CATHEDRAL ROCK CHURCH
Grading & Erosion Control Plans
Tract A, Struthers Ranch
Filing No. 2
El Paso County, Colorado

**CATHEDRAL ROCK CHURCH
TRACT A, STRUTHERS RANCH FILING NO. 2**

SITE GRADING AND
EROSION CONTROL PLAN

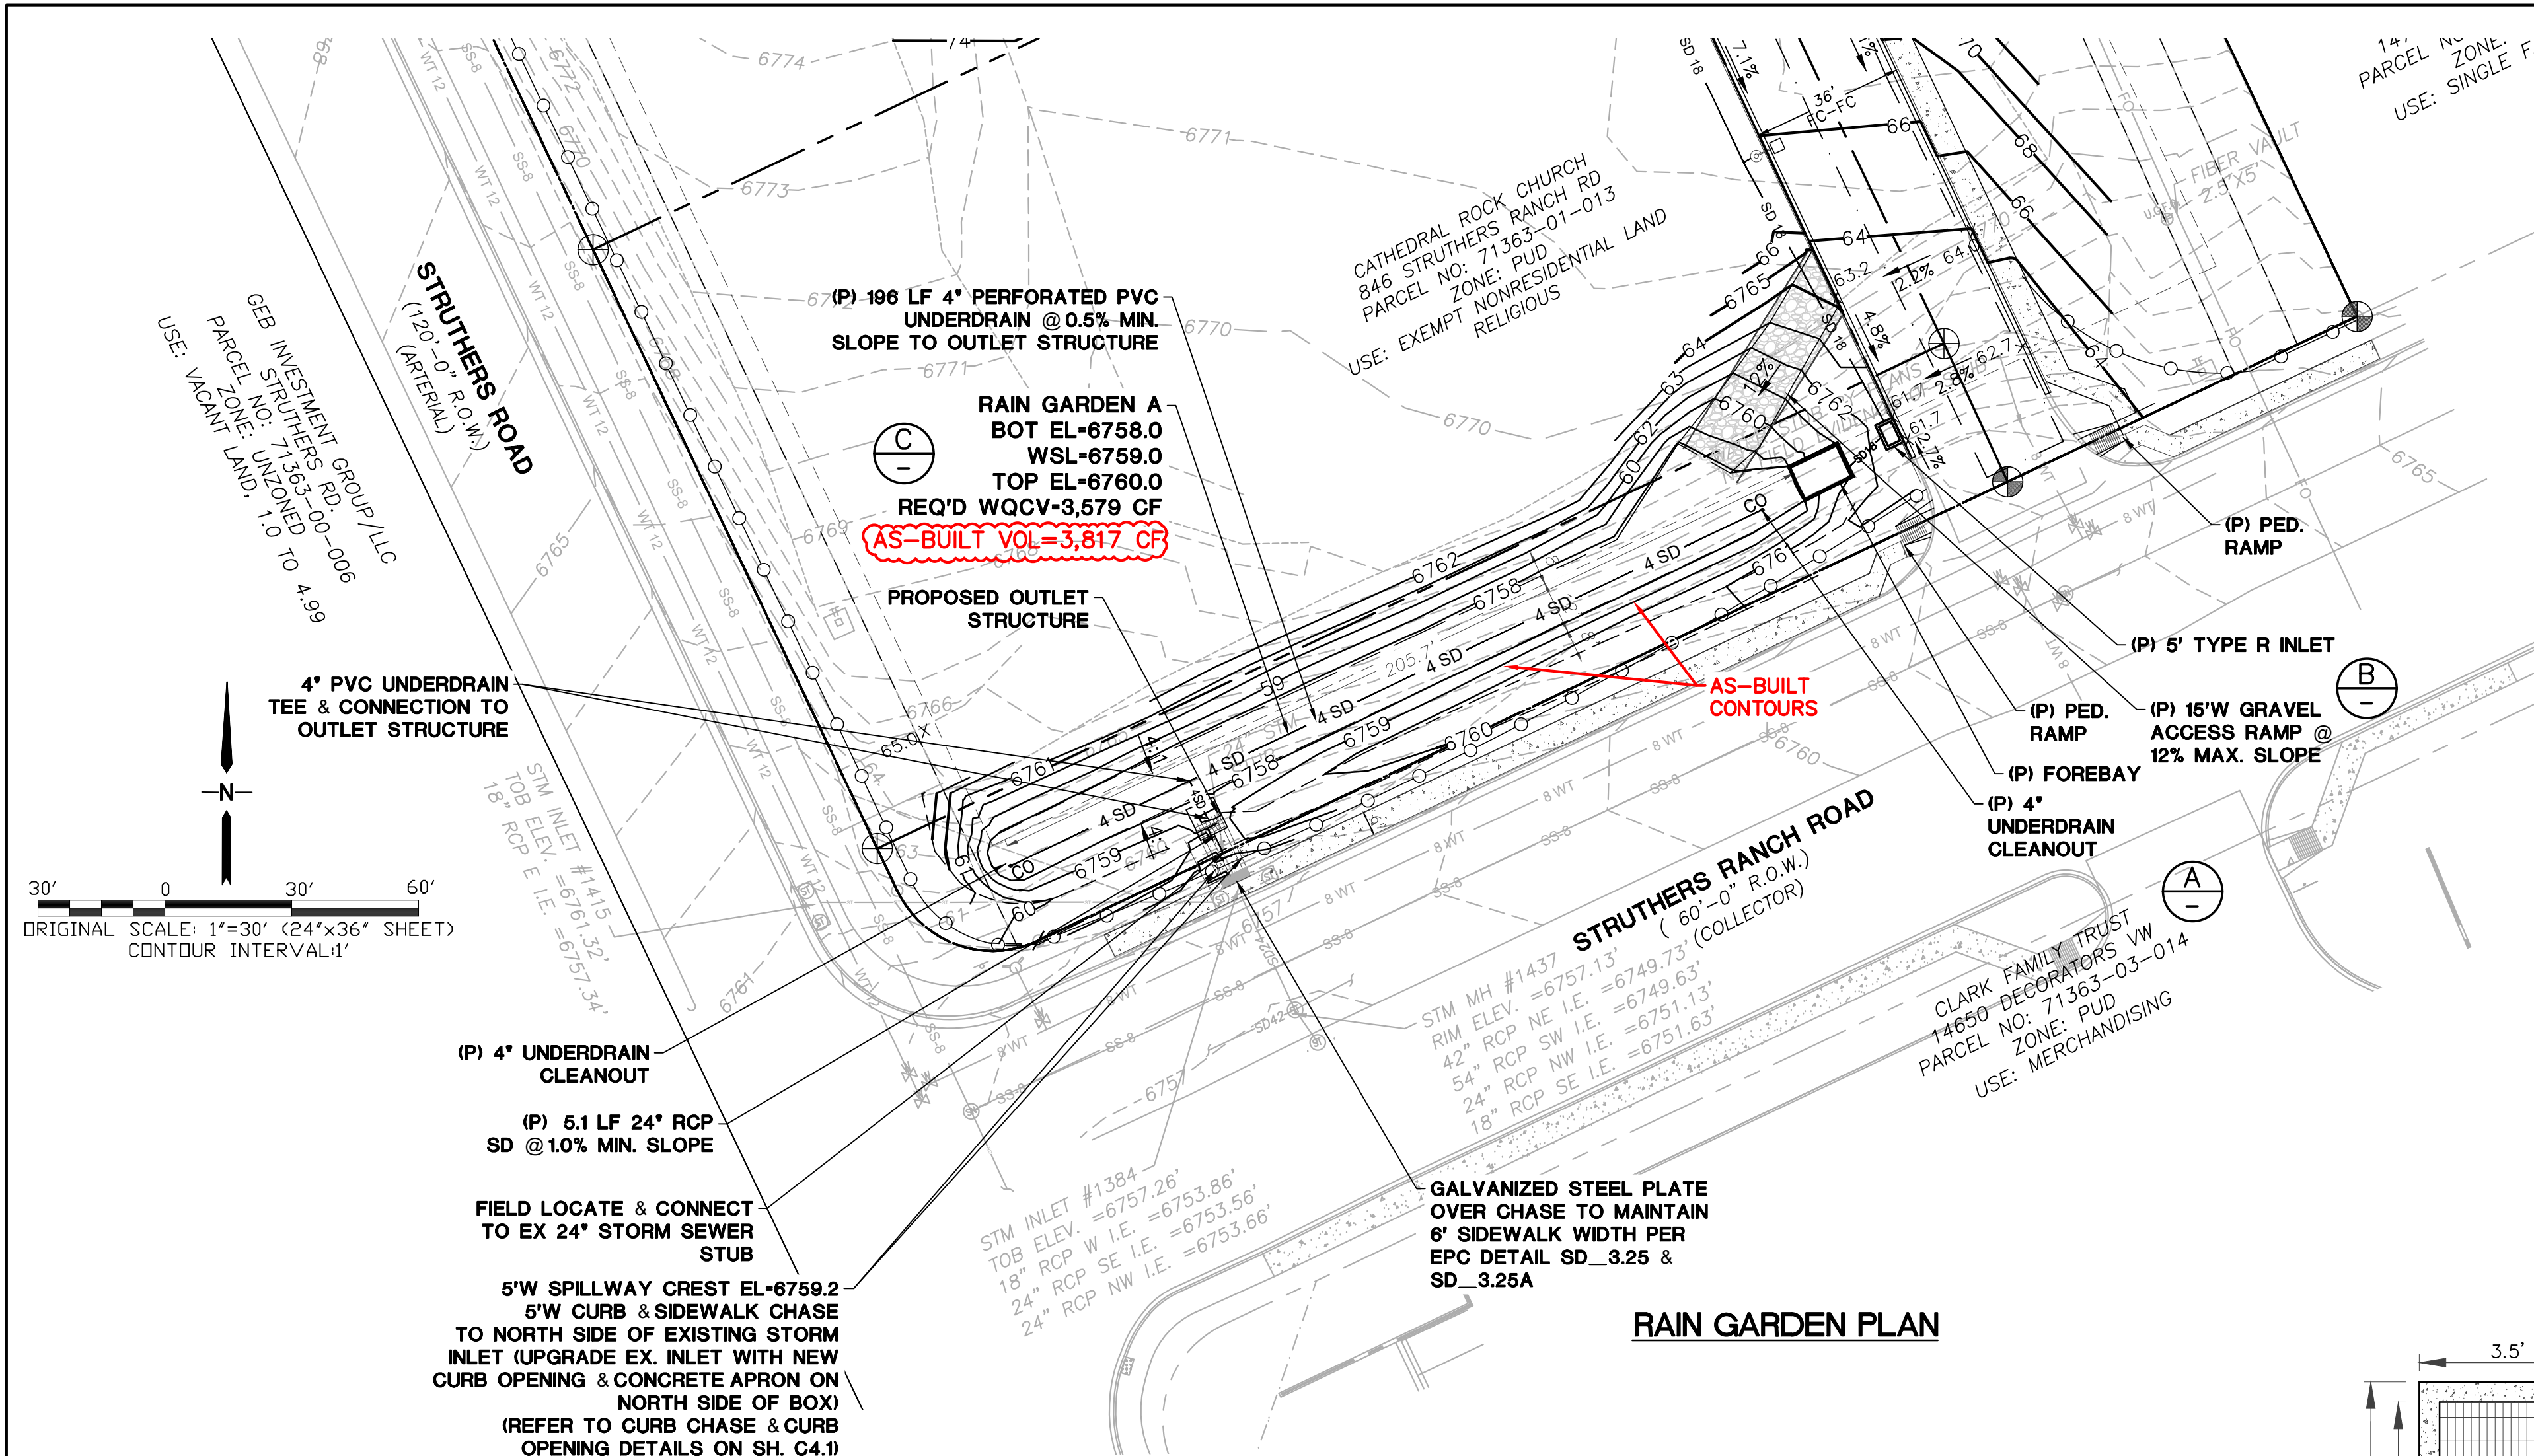
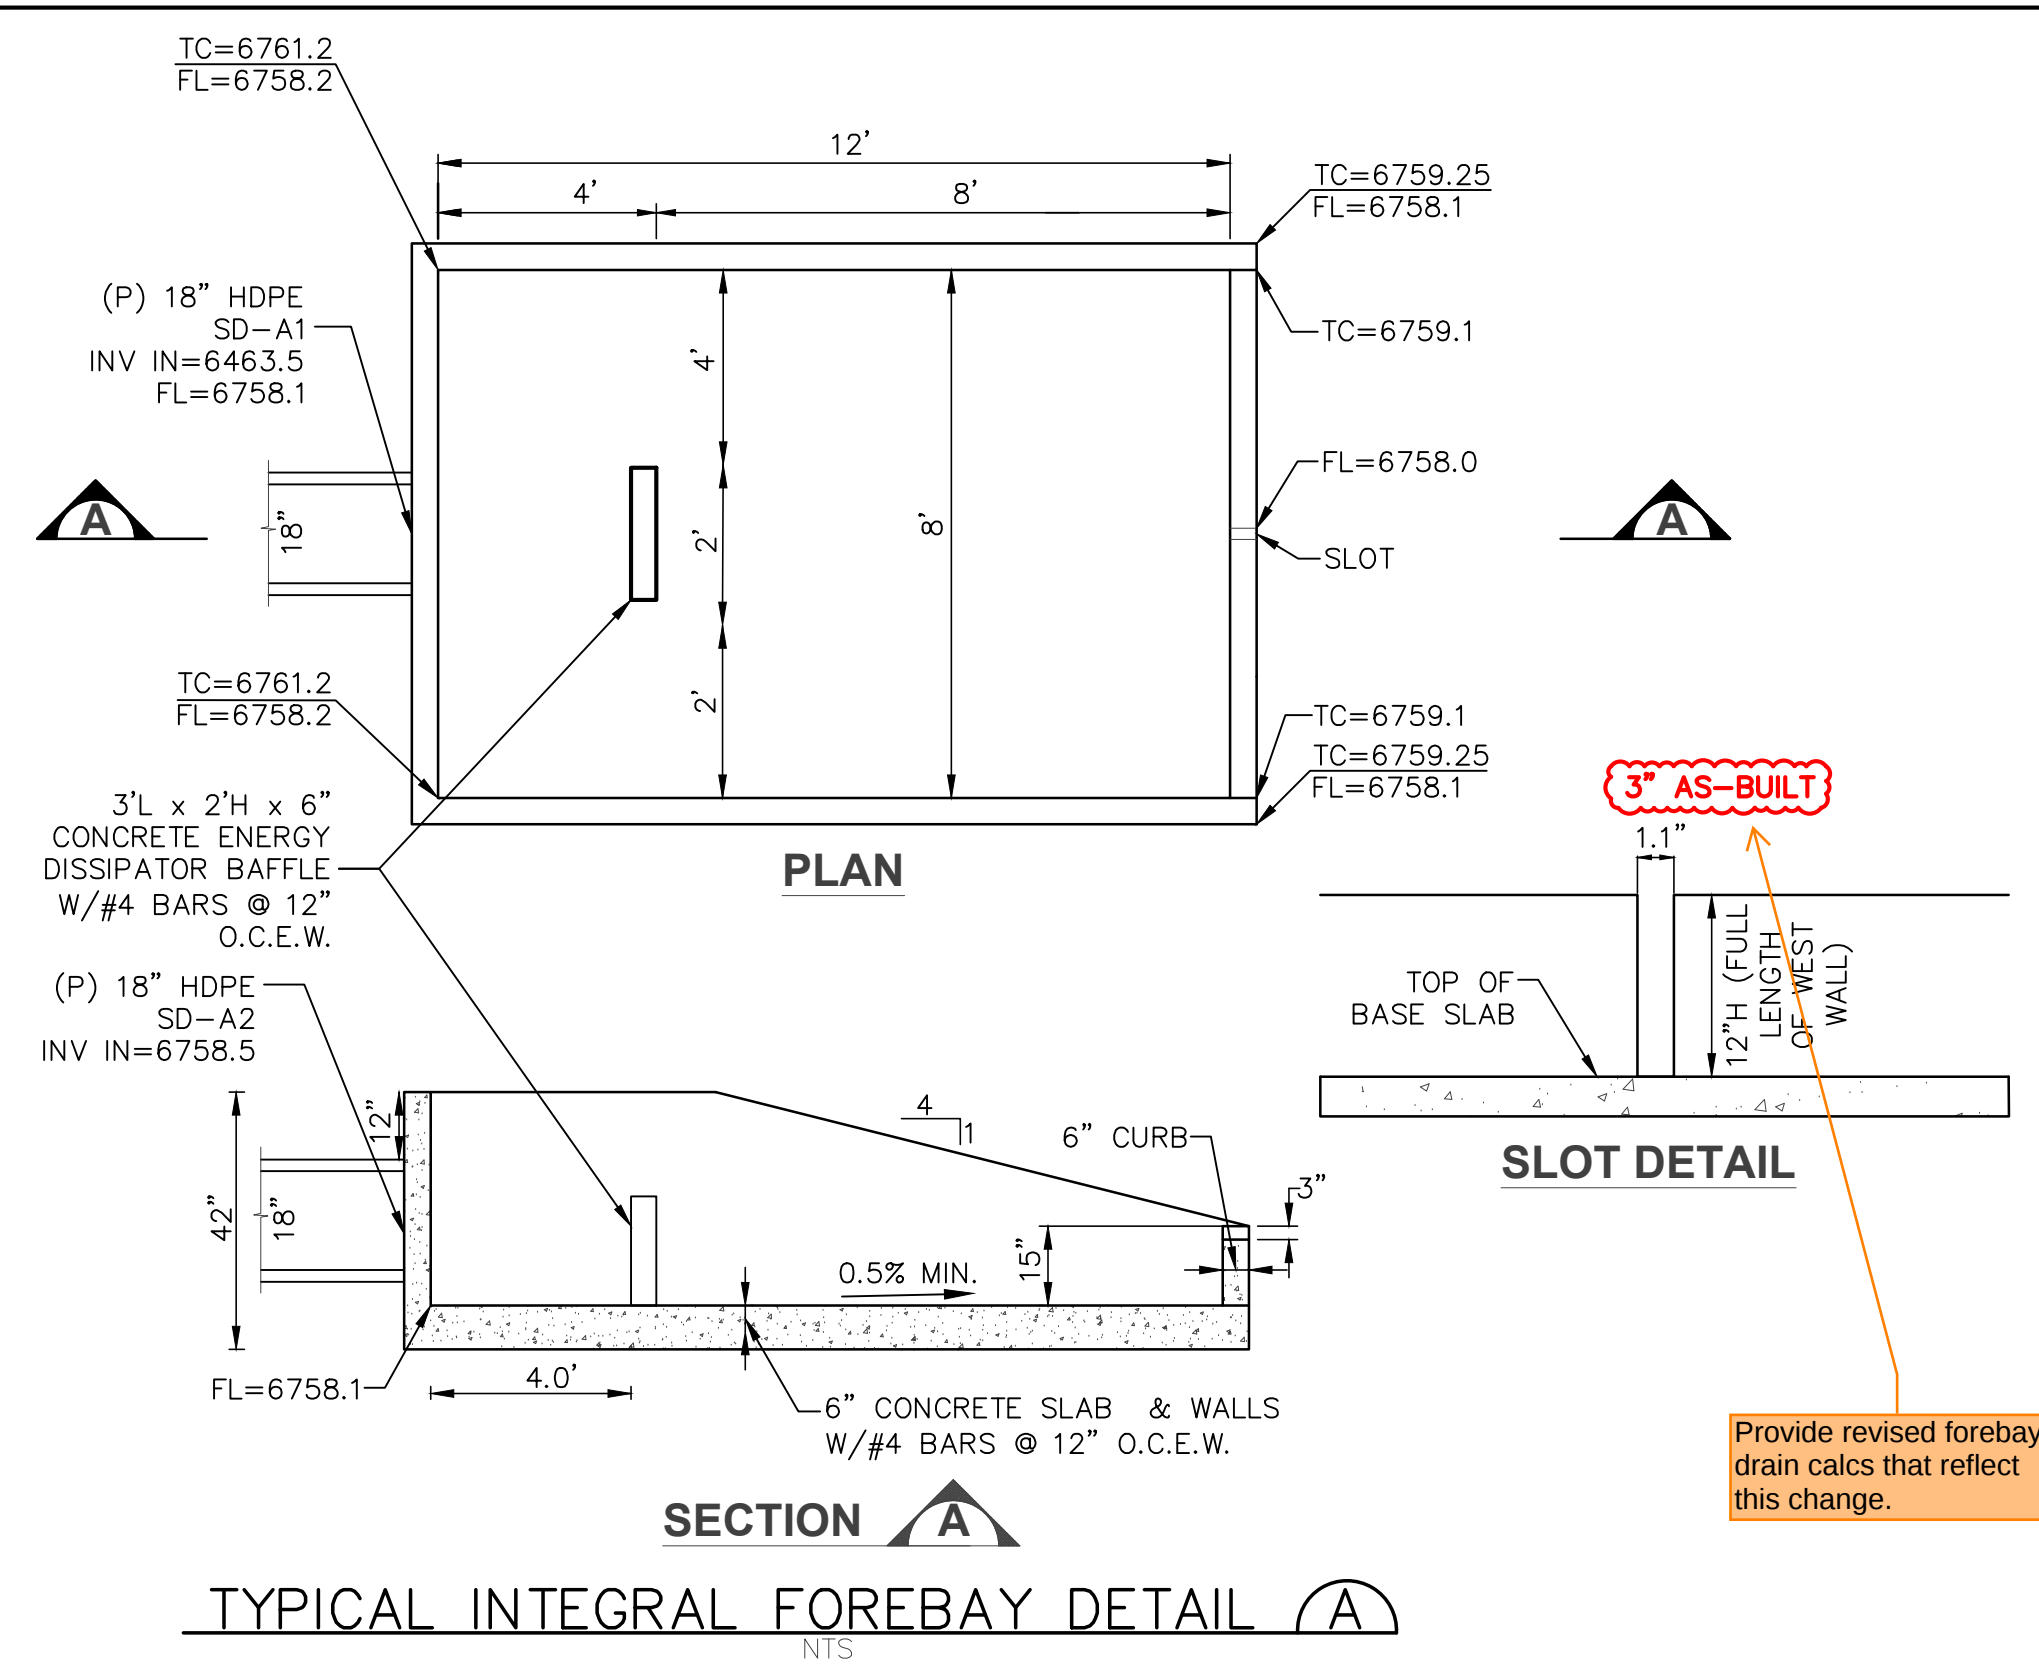
SW PA Punchlist finding:
"About 0.34 acres (~14,810 sq ft) of road base was installed where future building is proposed. This may affect the imperviousness of the site and may need alterations to the pond. Show deviation on as-builts. (Reference photos 9-10)."
ASB review comment: update the drainage/pond calcs and the as-builts accordingly.
